This letter is to inform you that our 2K bezel for cap series 1KS/1KBS/1KCS (and 1K/1KB/1KC) has been upgraded.

Picture 1 – Close Up

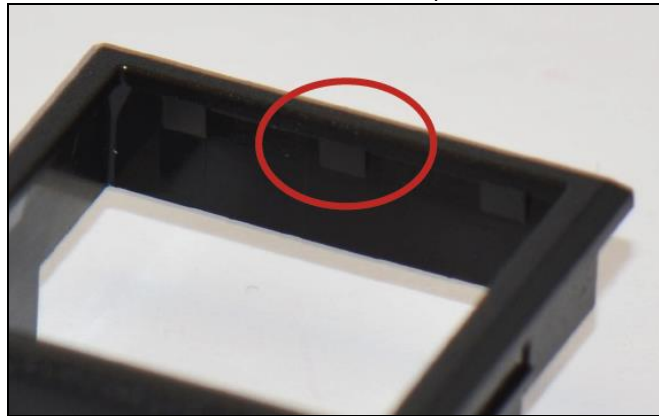
The "slopes" on the inside of the bezel have been widened and a third "slope" was added on all four sides, so now there are three "slopes" on all inner sides of each bezel. These "slopes" eliminate the chance of a cap getting stuck under the recess when pressing it unevenly.
